S-34-18 / Cadence at Town Center Transaction # 564122. AA # 3925 City of Raleigh
Development Services Department
One Exchange Plaza
Raleigh, NC 27602
(919) 996-2495
DS.help@raleighnc.gov
www.raleighnc.gov

REQUEST: Subdivision of a 27.5-acre tract zoned CX-5-PK-CU (Z-75-95) and SHOD-2 into

Design Adjustment Staff Response

PRELIMINARY SUBDIVISION PLAN CITY OF RALEIGH TRANSACTION #564122 CITY OF RALEIGH CASE # S-34-18 6301 TRIANGLE TOWN BOULEVARD RALEIGH, NORTH CAROLINA PROJECT NUMBER: SDP-17010

TRIANGLE TOWN BOULEVARD STREET SECTION EXHIBIT RALEIGH, NORTH CAROLINA STREET SECTION SITE PLAN EXHIBIT

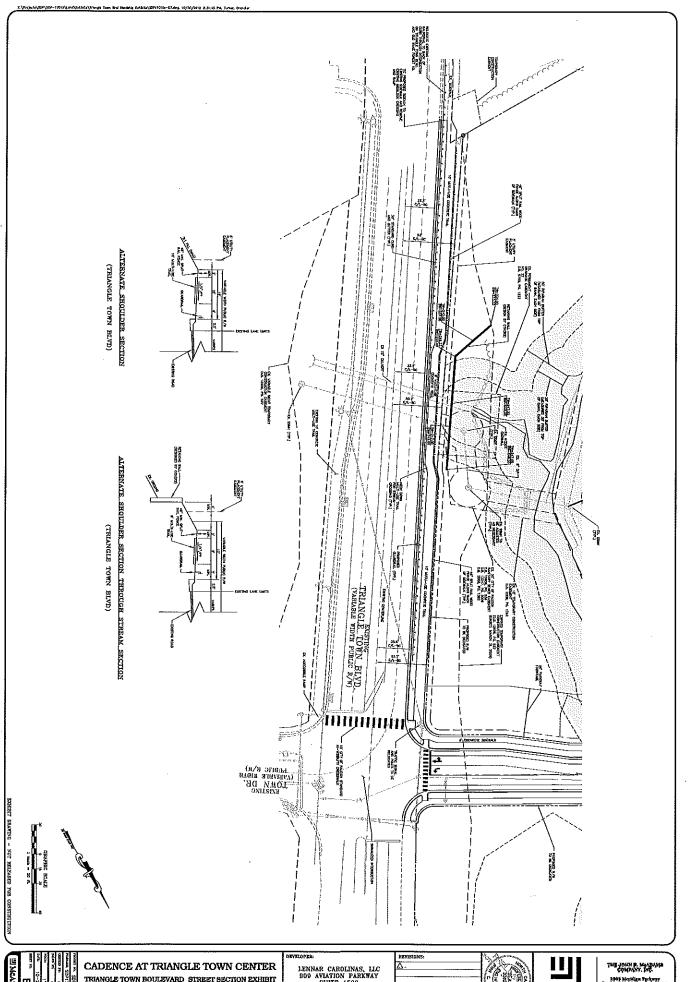
Section 8.4.6.D, Triangle Town Blvd (104' r/w, 76' b-b)

The existing Triangle Town Blvd is located in a variable width right-of-way. Triangle Town Blvd is classified as a 4-lane Divided Avenue per the approved City of Raleigh Street Plan. The pavement section of the existing street meets the minimum for a 4-lane Divided Avenue and right-of-way will be dedicated, achieving the minimum required right-of-way width. Applicant is requesting a Design Adjustment to allow the current street section to remain without additional improvements or expansion based on the following findings from Section 8.3.6 of the City of Raleigh UDO:

Staff supports the Design Adjustment application to alter the UDO approved street section for an Avenue 4-Lane, Divided. The driving force that creates a difficultly when designing and building out the ultimate UDO approved street section is existing grades, environmental features, and a Public Utilities easement/infrastructure that exist in the area. To meet the intent of the UDO approved street section while limiting the impact to the aforementioned existing conditions, an alternate street section/streetscape has been proposed. To meet the intent of the street section, a multi-use path is being extended along the length of their property and connecting to the existing greenway trail that stops at their southern property line. By doing this, we are able to obtain the bicycle facilities that are currently the only missing aspect of the street section along their frontage. Also, due to the existing environmental features, grade challenges, and Public Utilities infrastructure, the streetscape is being modified as well. For approximately 250' as the streetscape crosses the environmental feature, the planting strip is being reduced to only accommodate a guard rail to ensure pedestrian/bicycle safety and the path is being reduced to 8' wide. Once the streetscape clears the environmental feature, it will return to a typical 6' planting strip with street trees, a 10' multi-use path, and full public right-of-way dedication.

BLOCK PERIMETER EXHIBIT

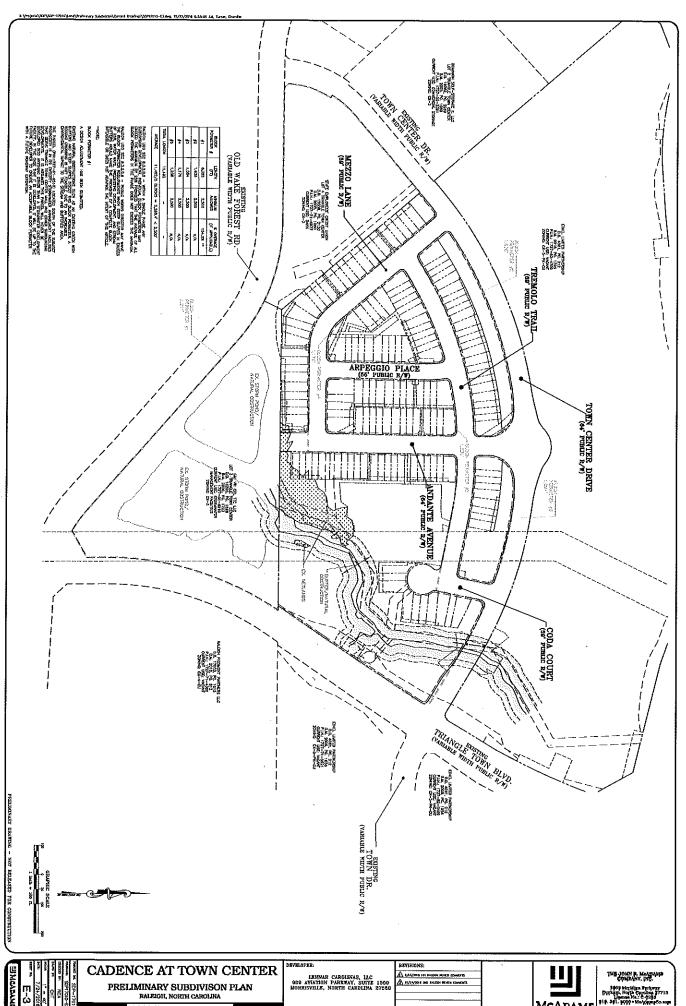
Section 8.3.2, Block Perimeter Maximum

The block perimeter, as measured from existing public rights-of-way, exceeds the maximum permitted in the CX-5 district of 2,500'. Approval of the requested Design Adjustment is justified based upon the following findings:

- The proposed design meets the intent of the City of Raleigh UDO. The parcel is located in an area that is mostly developed and contains an existing street network. The construction of new through street would require the disturbance of existing regional stormwater control features to the south, or sensitive environmental features (including steep slopes, wetlands, streams and associated stream buffers, and Tree Conservation Areas) to the east. The Triangle Town Center Development was approved and constructed prior to the adoption of the current City of Raleigh UDO.

7. adjacent to or in the vicinity of the site.
	YES NO NO
ST/	AFF FINDINGS
	f supports the request for a Design Adjustment as it relates to Block Perimeter standards. The
	posed development has maximized the site and has stubbed streets in all applicable locations to meet
	k perimeter standards. One newly created block does not comply. The block not in compliance would lire a road to be constructed through a previously dedicated and completed stormwater management
area	a. To help improve interconnectivity, the proposed development is extending a multi-use path along
hei	r frontage and connecting to an existing greenway trail that stops at their southern property line. With
	extension, the entire block as a whole is wrapped with sidewalk or a multi-use path so that pedestrian
